Addendum No. 2

Bid No. 19/20-02MO, University High School High Voltage Replacement March 31, 2020

UNIVERSITY HIGH SCHOOL
 HIGH VOLTAGE REPLACEMENT
 IRVINE UNIFIED SCHOOL DISTRICT

**SINGLE LINE
 DIAGRAM**

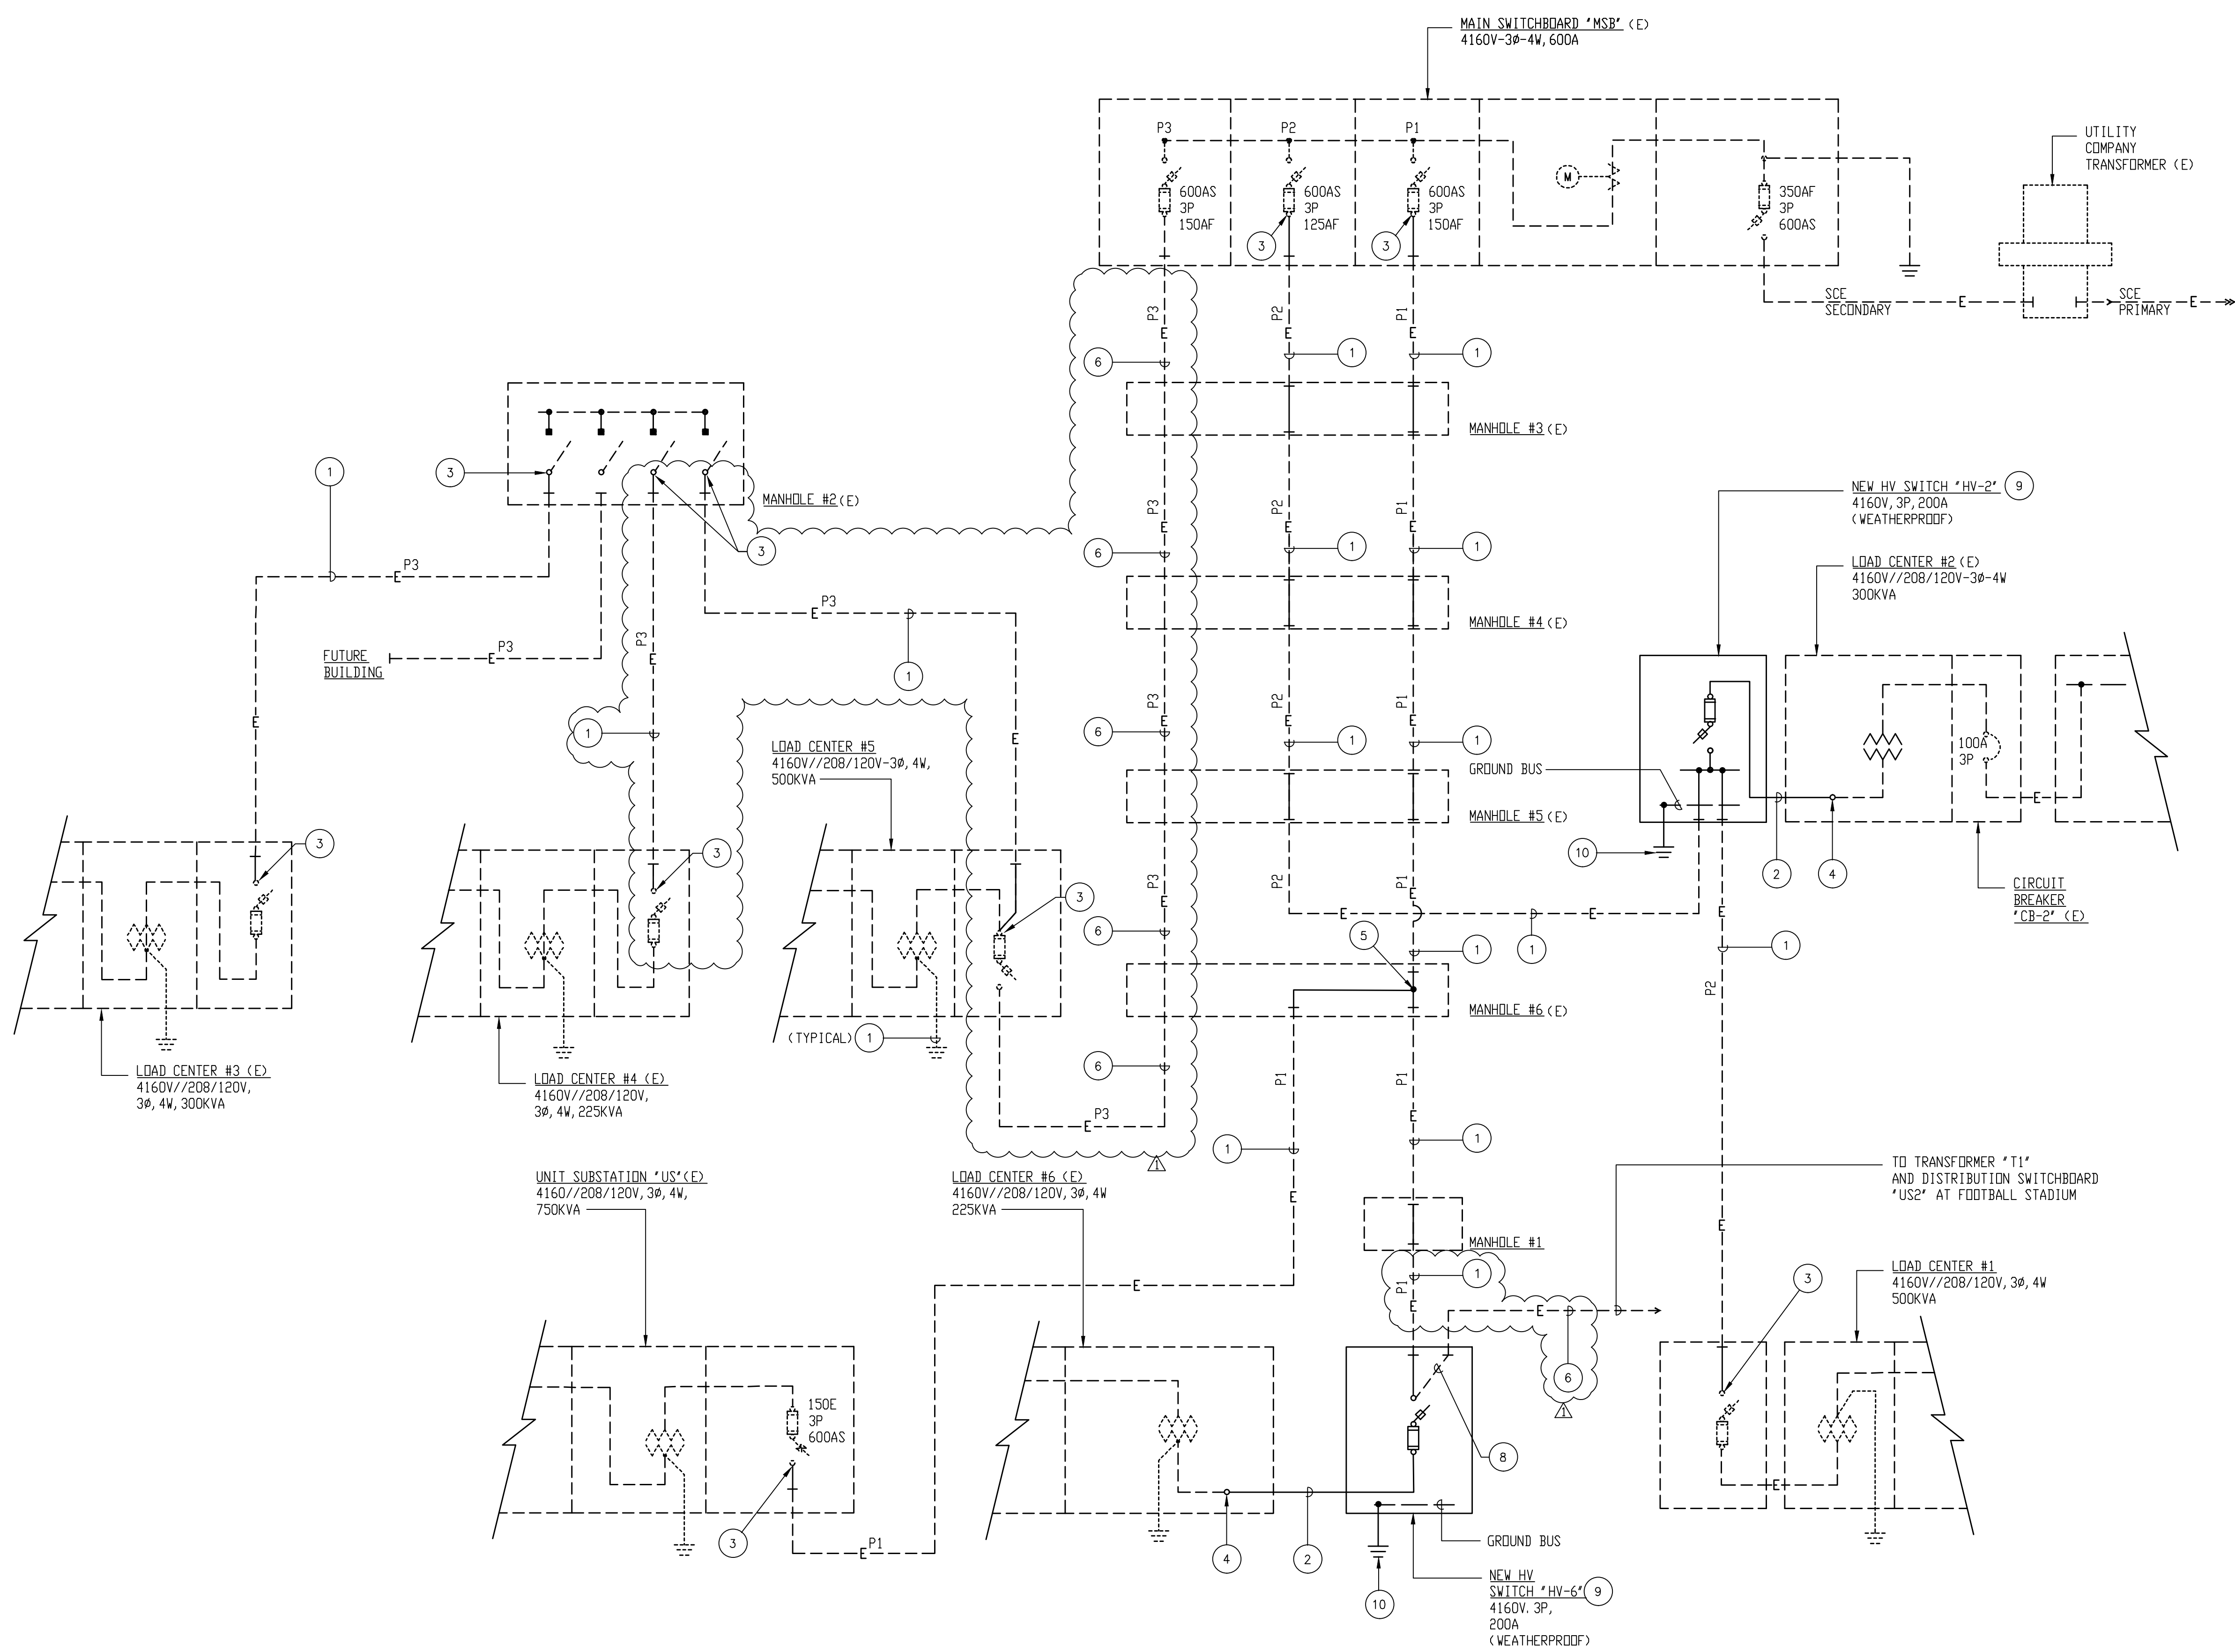
3. Please provide a clear, complete and defined feeder schedule. Such as P1 removed from Manhole 1 to 2, Install new P1 manhole 1 to 2 and so on or single line plan with feeders highlighted or colored in for removal and installation would be acceptable also. From Manhole 4 on, there seems to be slight confusion in routing. The difference in cable length and labor will drastically alter bid.

4. From Job walk understanding, circuit P3 is newer and no modifications are to be performed?

2.3.2 Sheet E0.2

2.3.2.1 Revise Single Line Diagram as shown on attached revised Drawing E0.2 and as follows:

2.3.2.1.1 Revised Plan Notes to clarify portion of existing HV feeders to remain.

2.3.2.1.2 Revised HV Feeder P3 to be replaced between Manhole #2 and Load Center #5, and from Manhole #2 and Load Center #4.

Response: See the attached sheets AD2-E0.2 and AD2-E1.0.

Response: See the attached sheets AD2-E0.2 and AD2-E1.0.

SITE ELECTRICAL PLAN

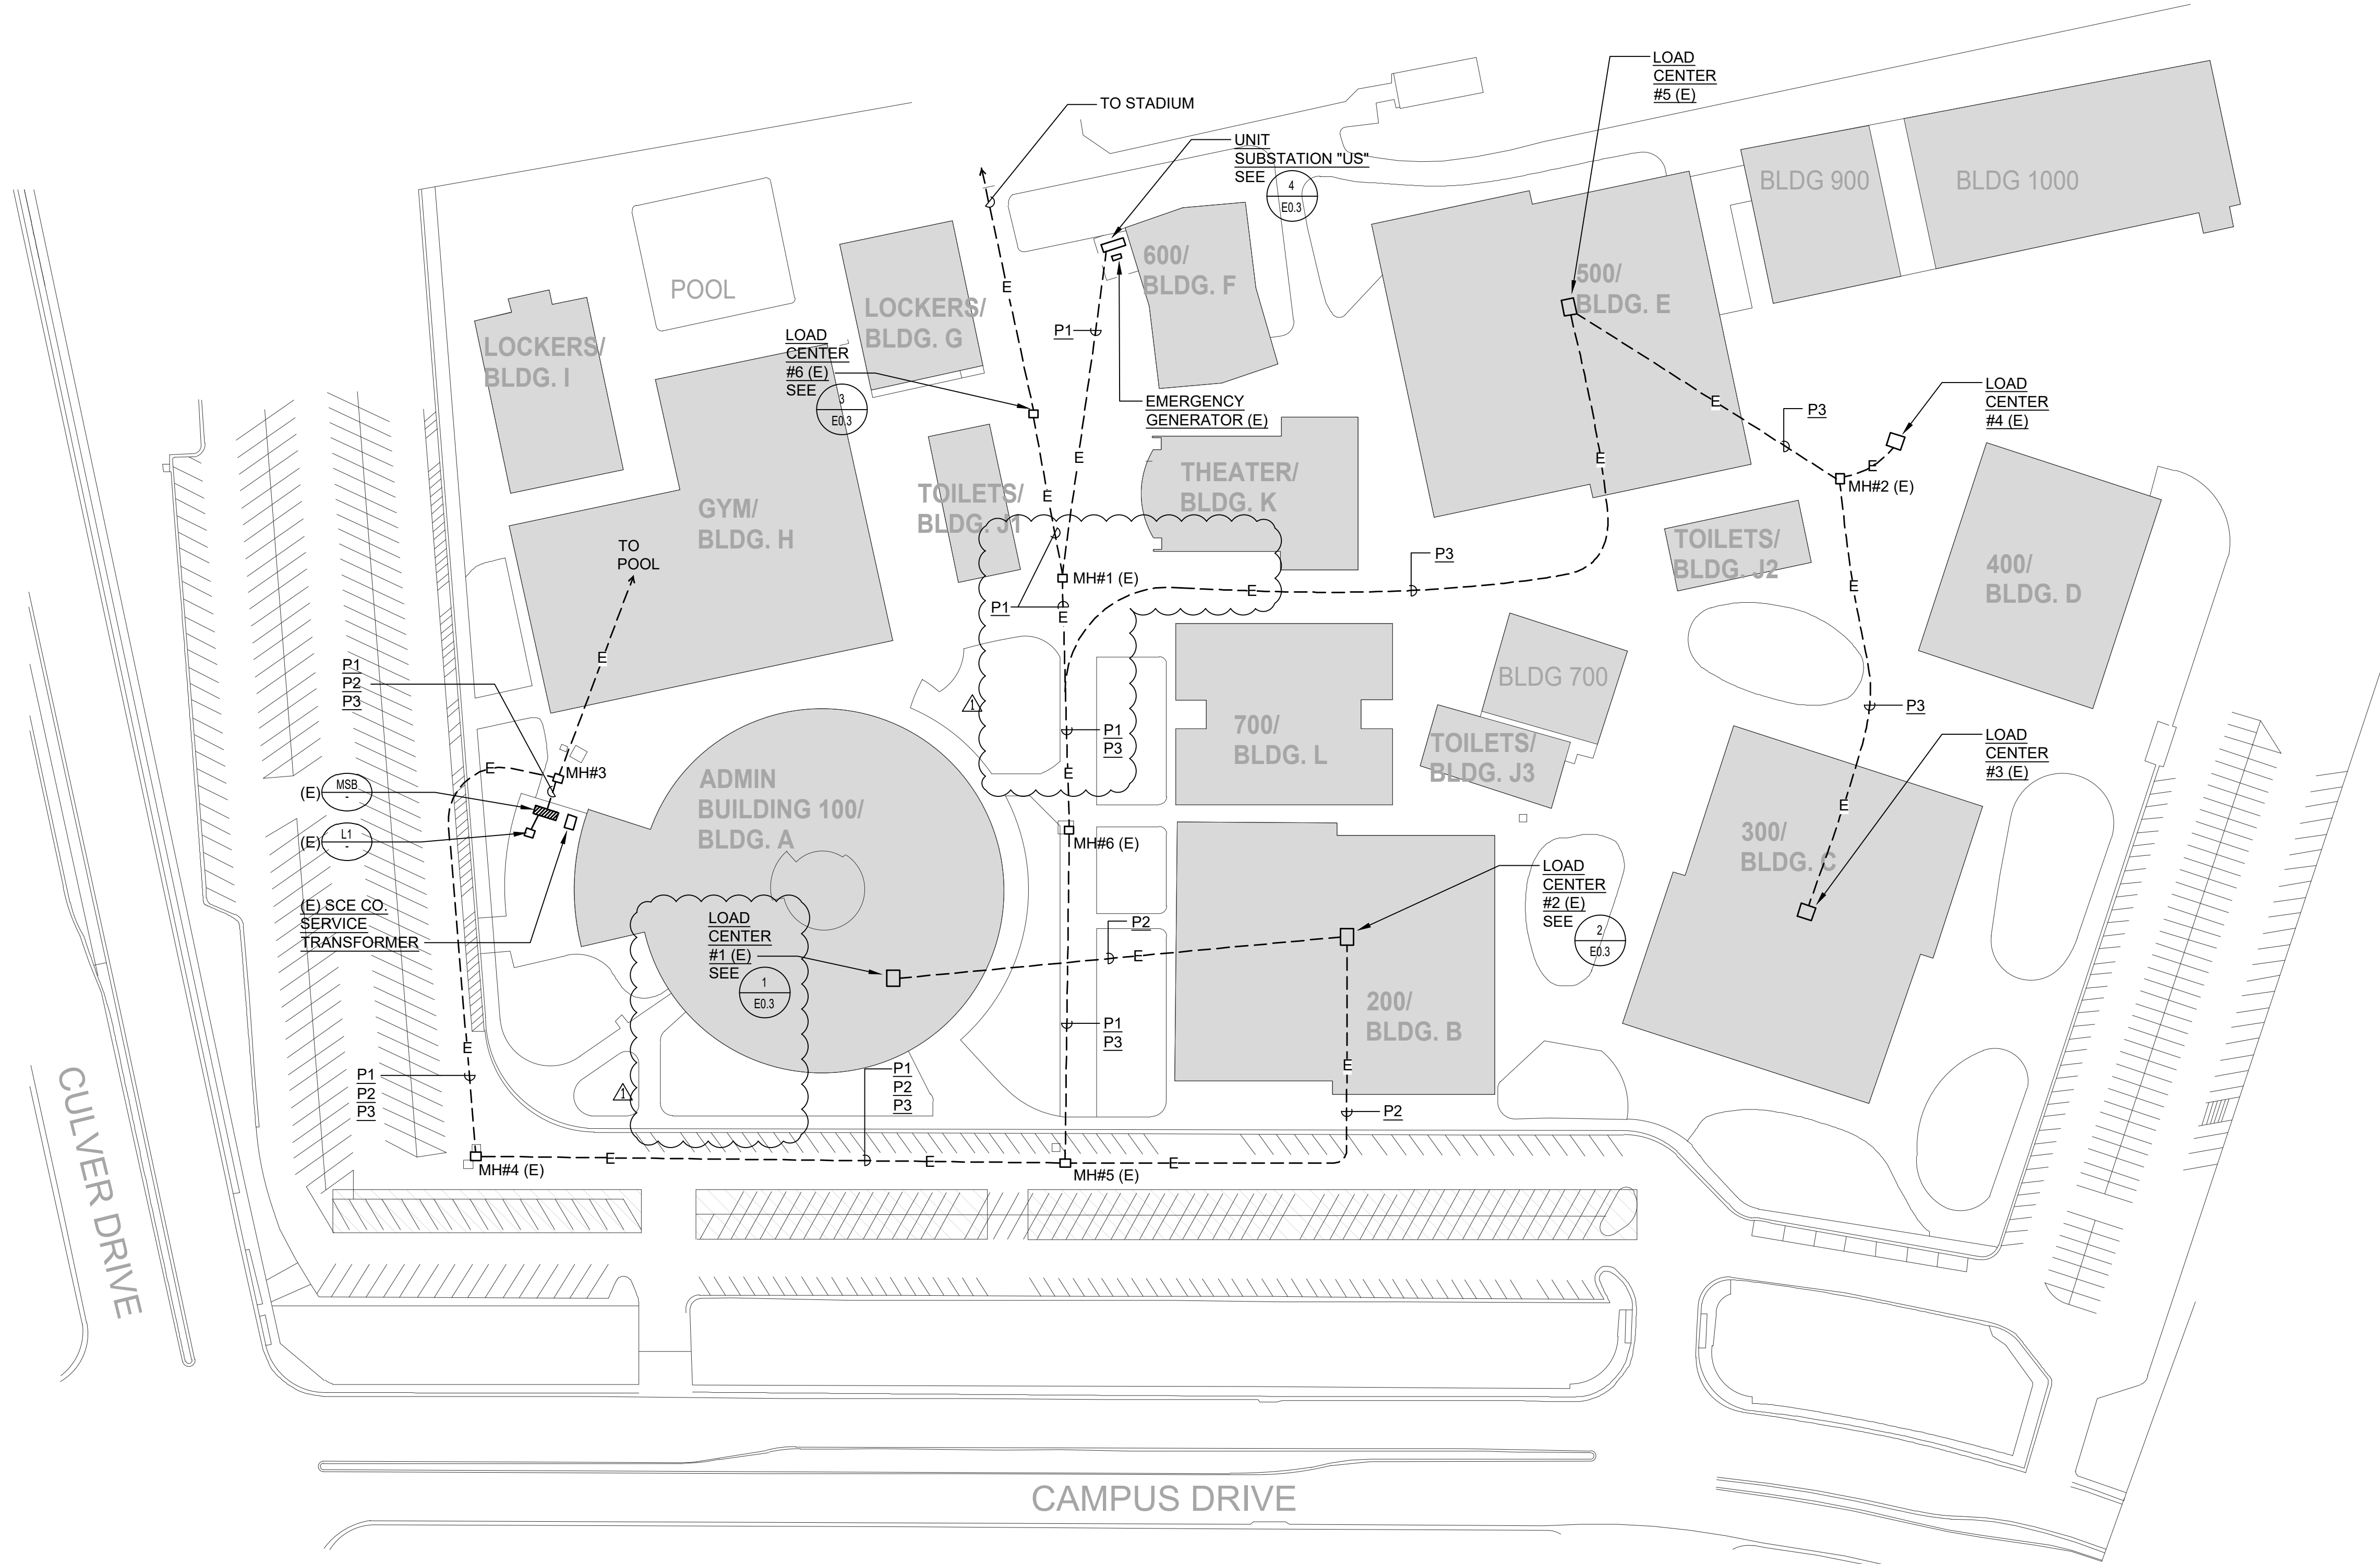
2.3.3 Sheet E1.0

2.3.3.1 Revise Site Electrical Plan as shown on attached revised Drawing E1.0 and as follows: Revised HV Feeder P3 connection to Manhole #6 in lieu of Manhole #1.
